Access Compliance Report Public Rights-of-Way (Curb Ramps)

Main Street: FAUNA_DR Cross Street: FAUNA_DR Location: N

ADA ID: RPRK211124123716 Ramp Type: Type 6 - Directional 1 Initial Pass/Fail: Fail Overall Compliance: No Severity Score: 2

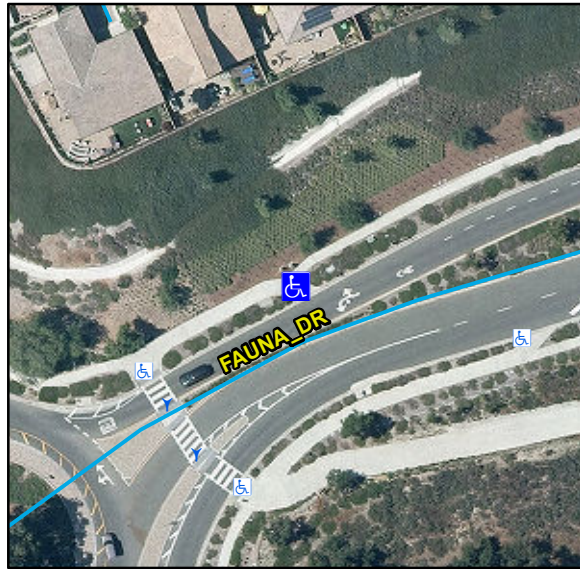
Compliance	Description	Data	Compliance	Description	Data
N/A	Ramp Length (in)	104	N/A	Flare Type LT	
Yes	Ramp Width (in)	134			N/A
Yes	Ramp Run Slope (%)	3.7	N/A	Flare Slope LT (%)	N/A
No	Ramp Cross Slope (%)	2.2	N/A	Flare Traversable LT	N/A
N/A	Grade Break	N/A	N/A	Flare Type RT	
N/A	Grade Break Slope (%)	N/A			N/A
N/A	Grade Break Cross Slope (%)	N/A	N/A	Flare Slope RT (%)	N/A
	Addl Para Ramp Left?	No	N/A	Flare Traversable RT	N/A
	Addl Para Ramp Right?	No	N/A	DWS Provided	N/A
N/A	Landing Present	N/A	N/A	DWS Contrast	N/A
N/A	Landing Length (in)	N/A	N/A	DWS Length (in)	N/A
N/A	Landing Width (in)	N/A	N/A	DWS Full Width	N/A
N/A	Landing Run Slope (%)	N/A		DWS Offset Type	N/A
N/A	Landing Cross Slope (%)	N/A	N/A	DWS Left Offset (in)	N/A
N/A	Landing Movement Obstructed?	N/A	N/A	DWS Right Offset (in)	N/A
	Landing Movement Type	N/A			
N/A	Landing Shared	N/A			
N/A	Marked Crosswalk 1	No	N/A	Clear Space	N/A
	Crossing 1 Direction	SE	N/A	Clear Space To Crosswalk (in)	N/A

Remove & Replace Entire Ramp.
